Planning Commission Agenda

- 1. THE MATTER OF THE PROPOSED SITE PLAN REVIEW AND CONDITIONAL USE PERMIT FOR THE PROPOSED ISOVOLTA HT1 PLANT EXPANSION (LU 464-2025 & 465-2025) LOCATED AT 495 TERRITORIAL STREET.**

Staff Report
Harrisburg Planning Commission
Harrisburg, Oregon

THE MATTER OF THE PROPOSED SITE PLAN REVIEW AND CONDITIONAL USE PERMIT FOR THE PROPOSED ISOVOLTA HT1 PLANT EXPANSION (LU 464-2025 & 465-2025) LOCATED AT 495 TERRITORIAL STREET.

C1 - SAND FILTER PLAN

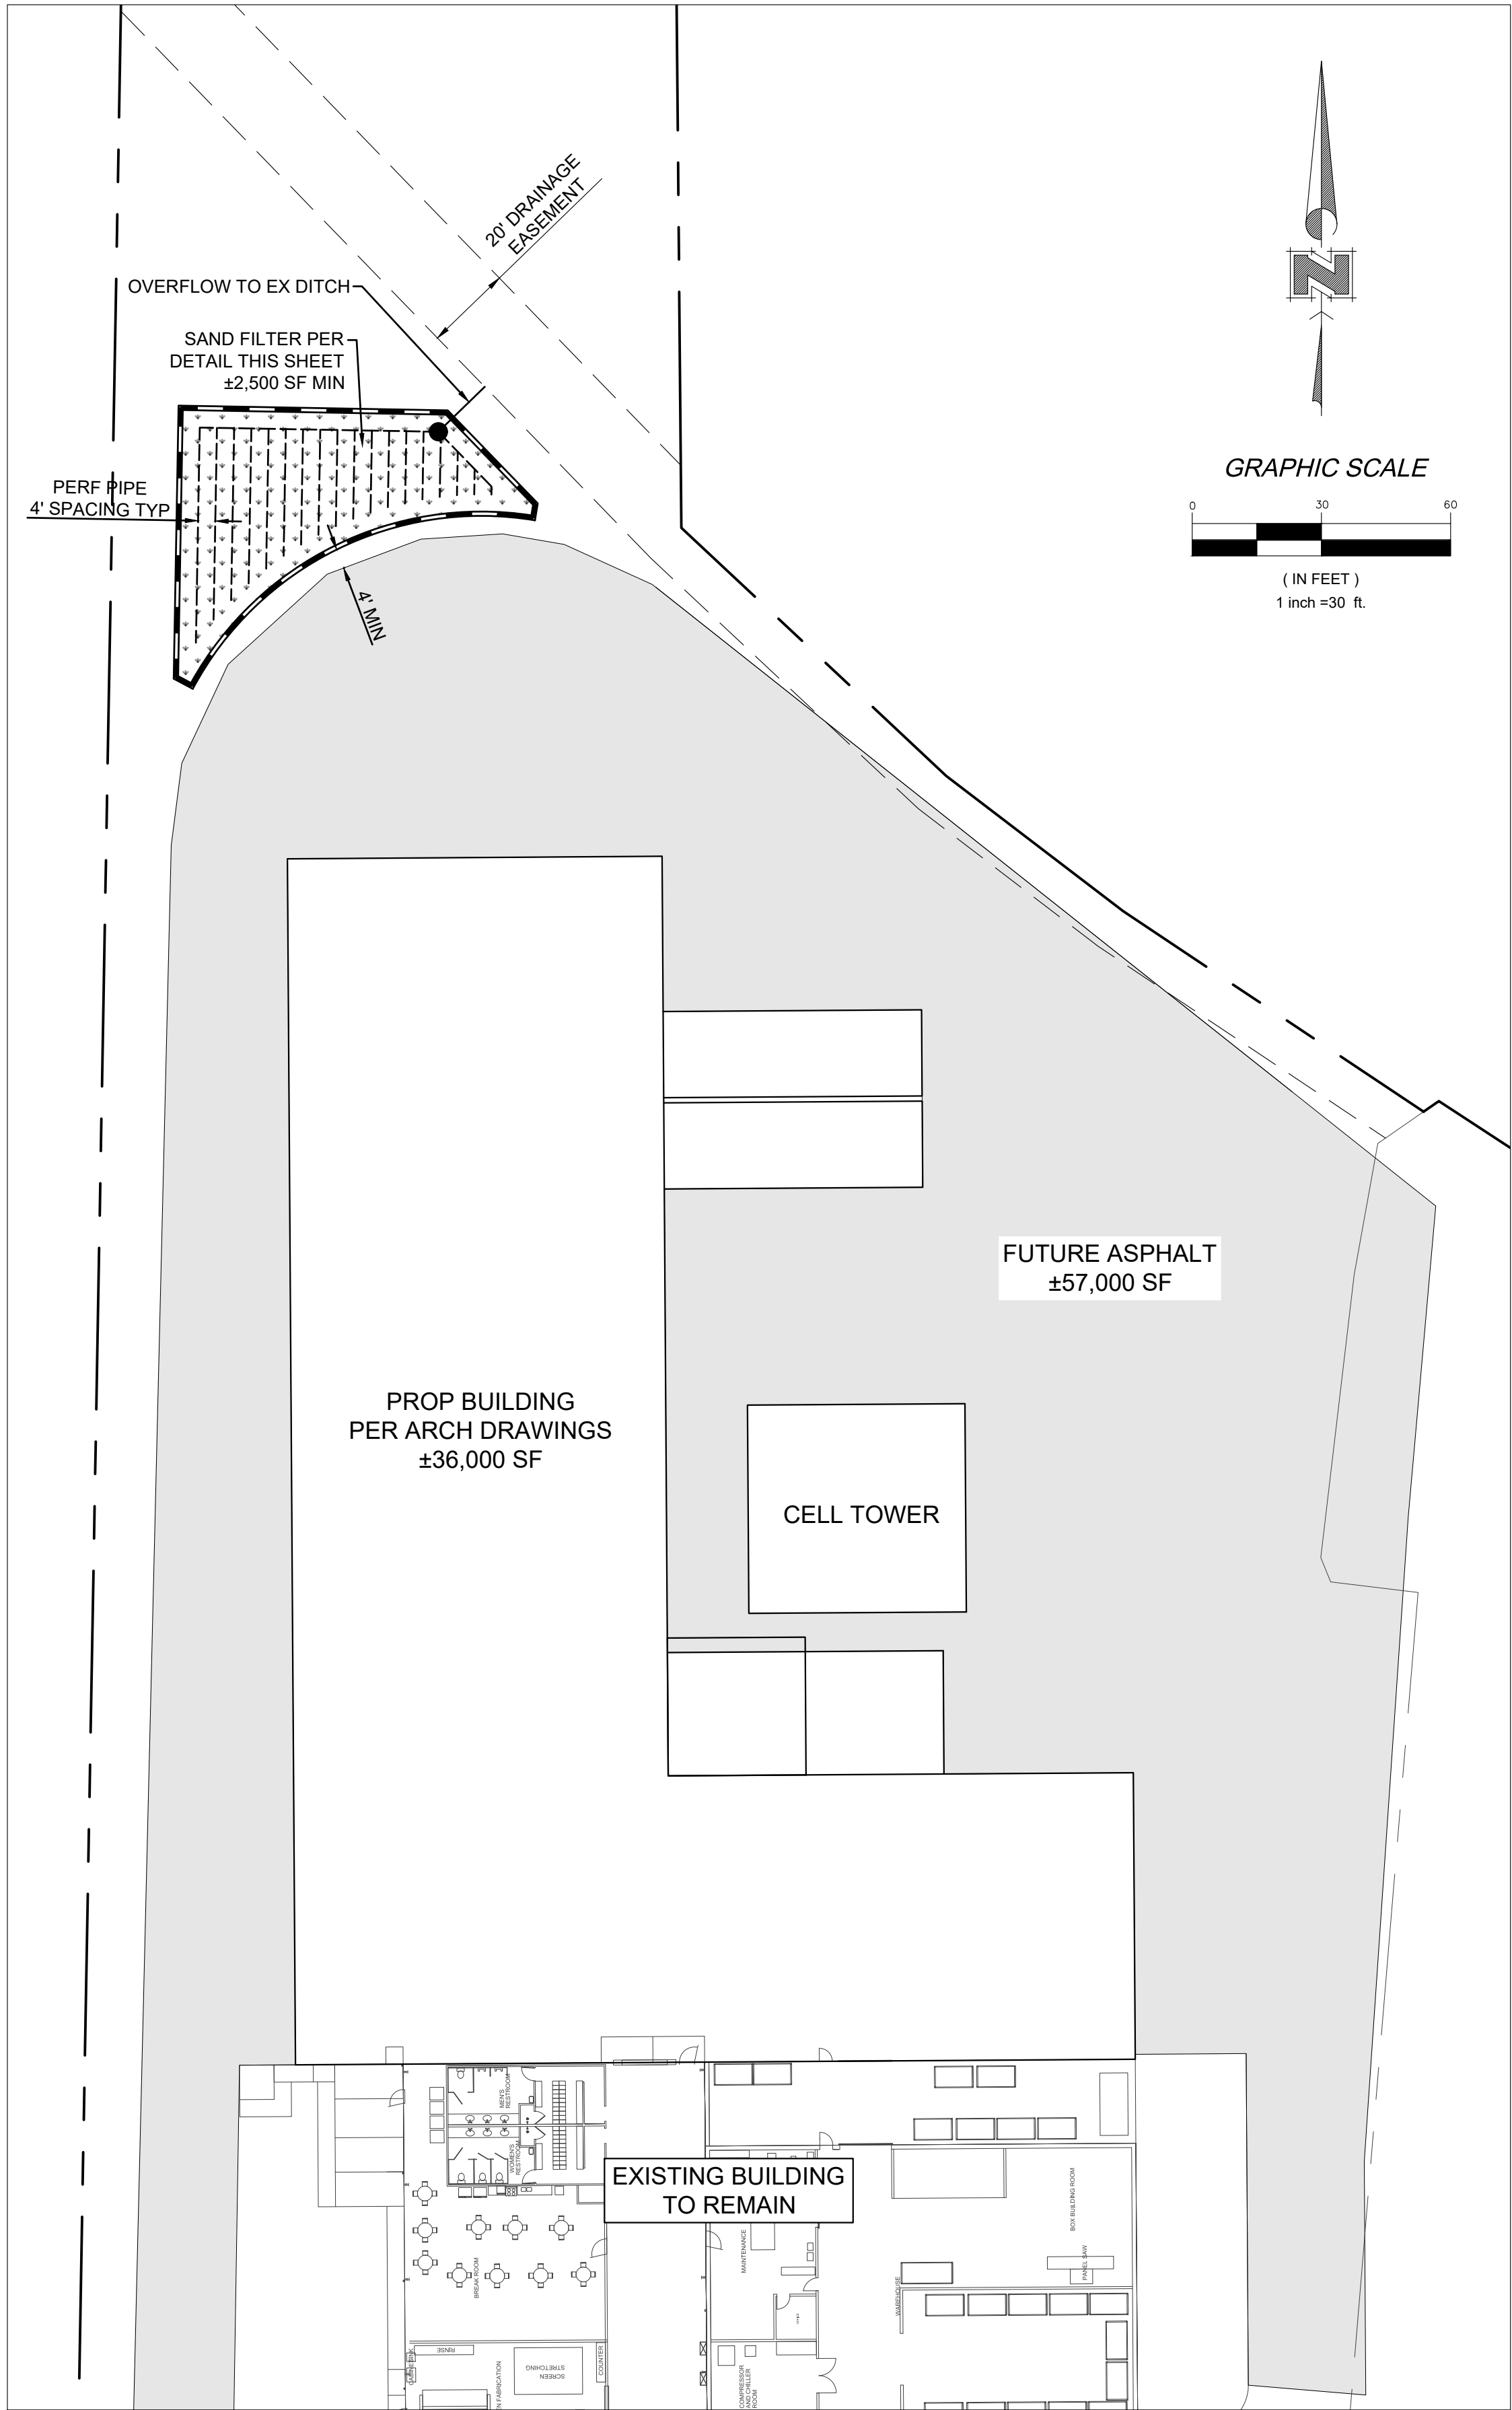
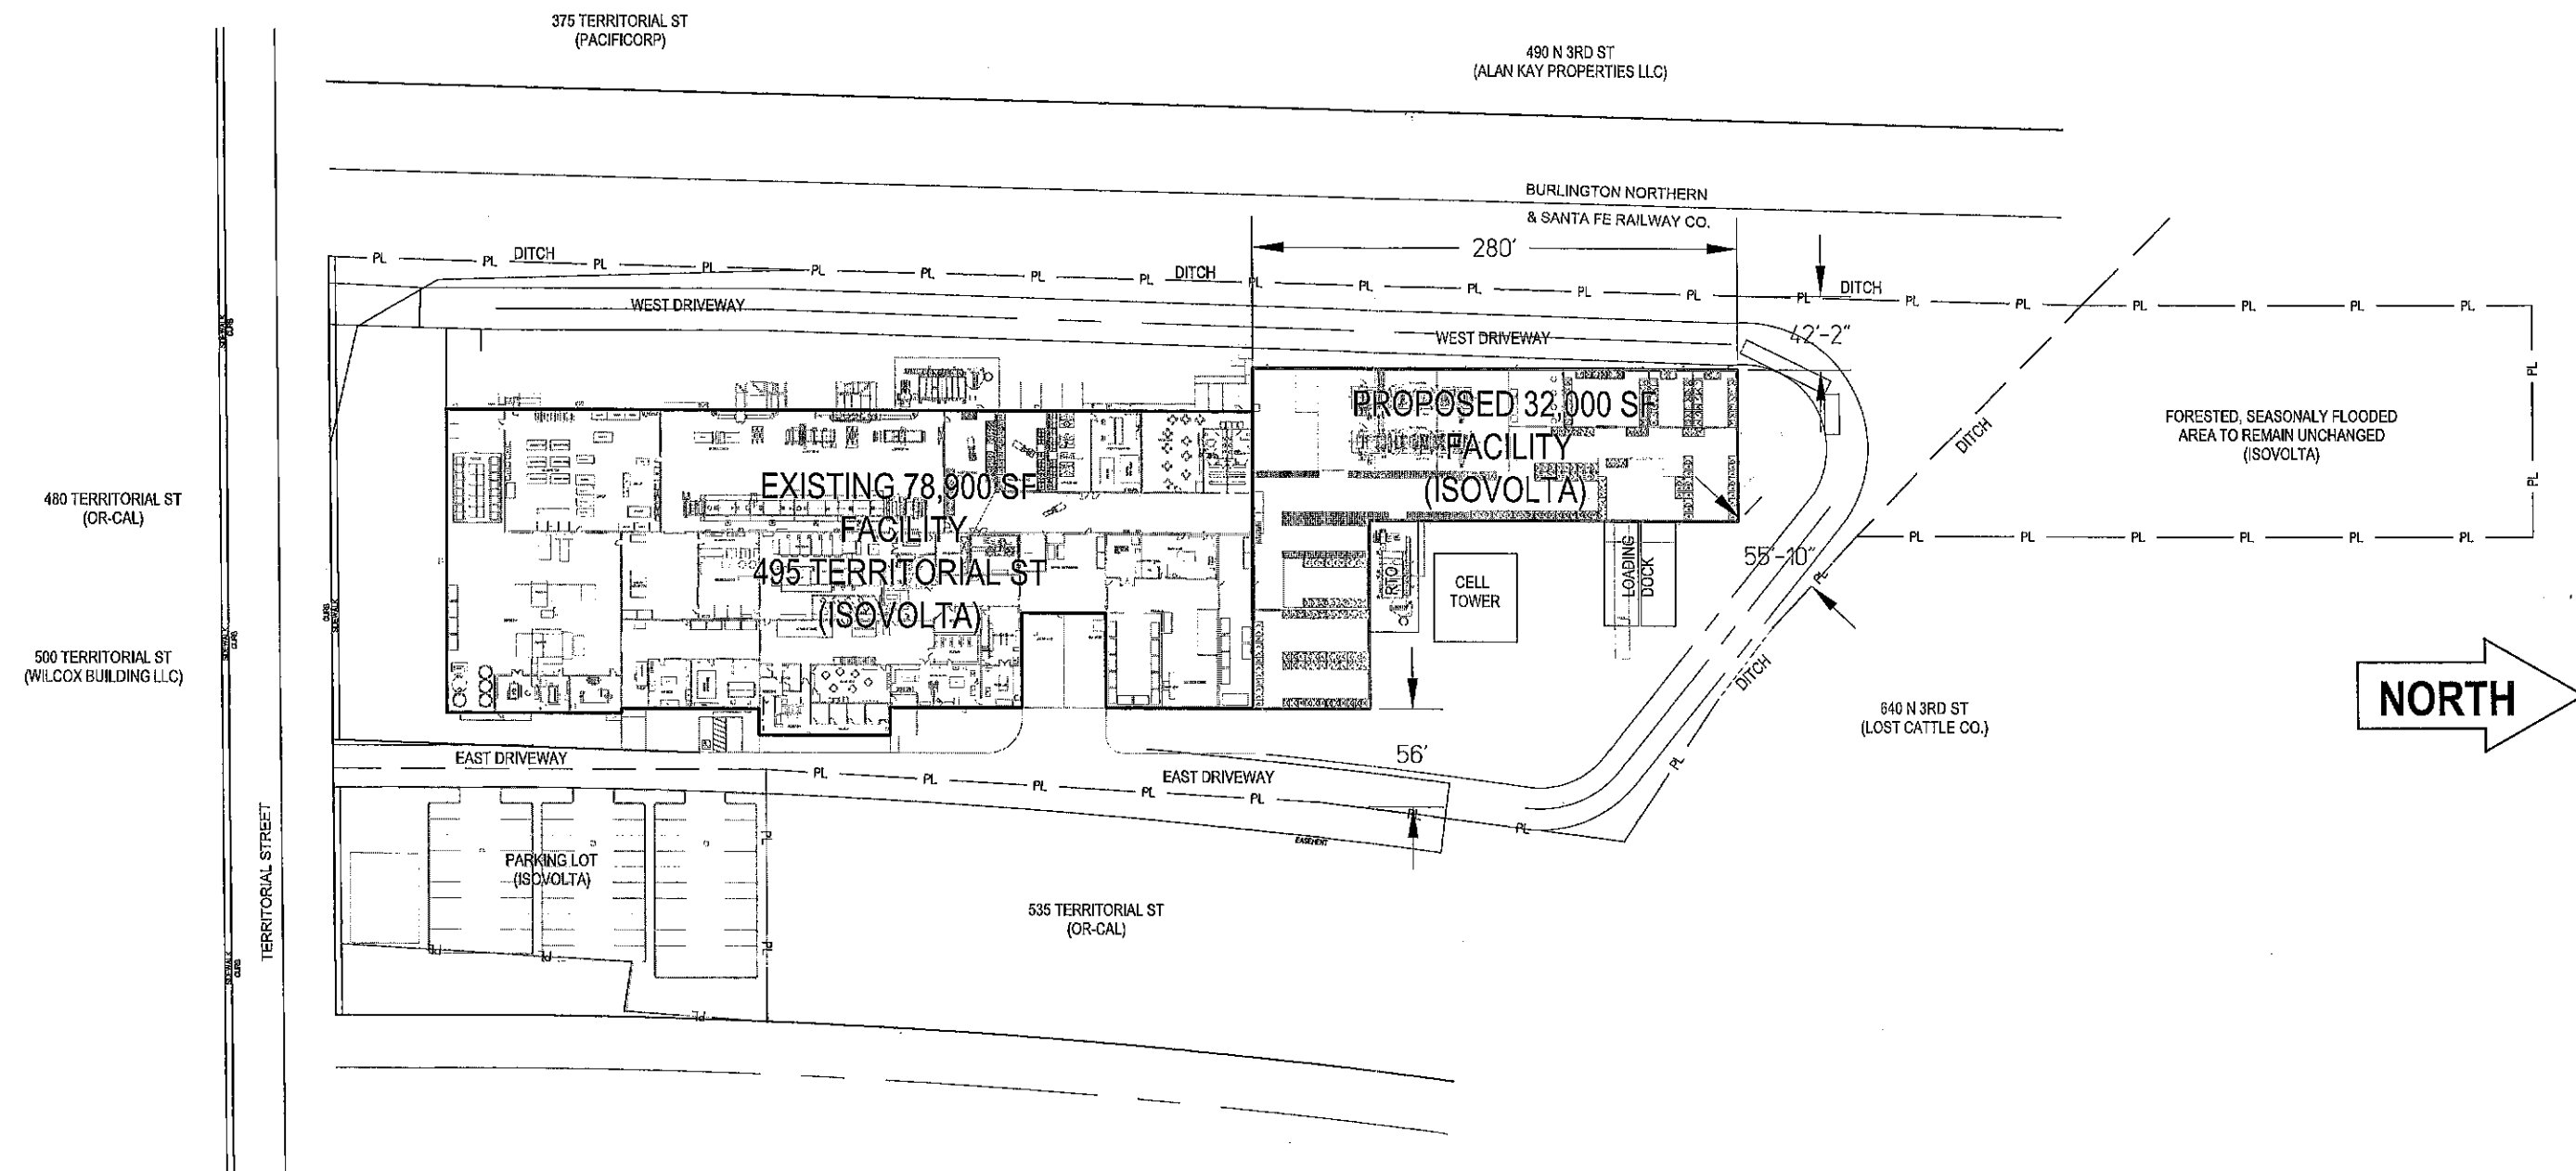
The City Public Works Department has reviewed the proposed stormwater facilities and the Applicant's analysis. The application is subject to the following conditions.

RECOMMENDED CONDITION: Prior to building permit submittal, the Applicant shall provide to the City a copy of sand filter Operations and Maintenance plan.¹

¹ The Applicant provided an Operations and Maintenance plan as an attachment to the Stormwater Narrative prepared by Favreau Engineering, dated February 1, 2025.

CONDITION NO. 8: SAND FILTER O&M: Prior to Building Permit submittal, the Applicant shall provide to the City a copy of sand filter Operations and Maintenance plan.
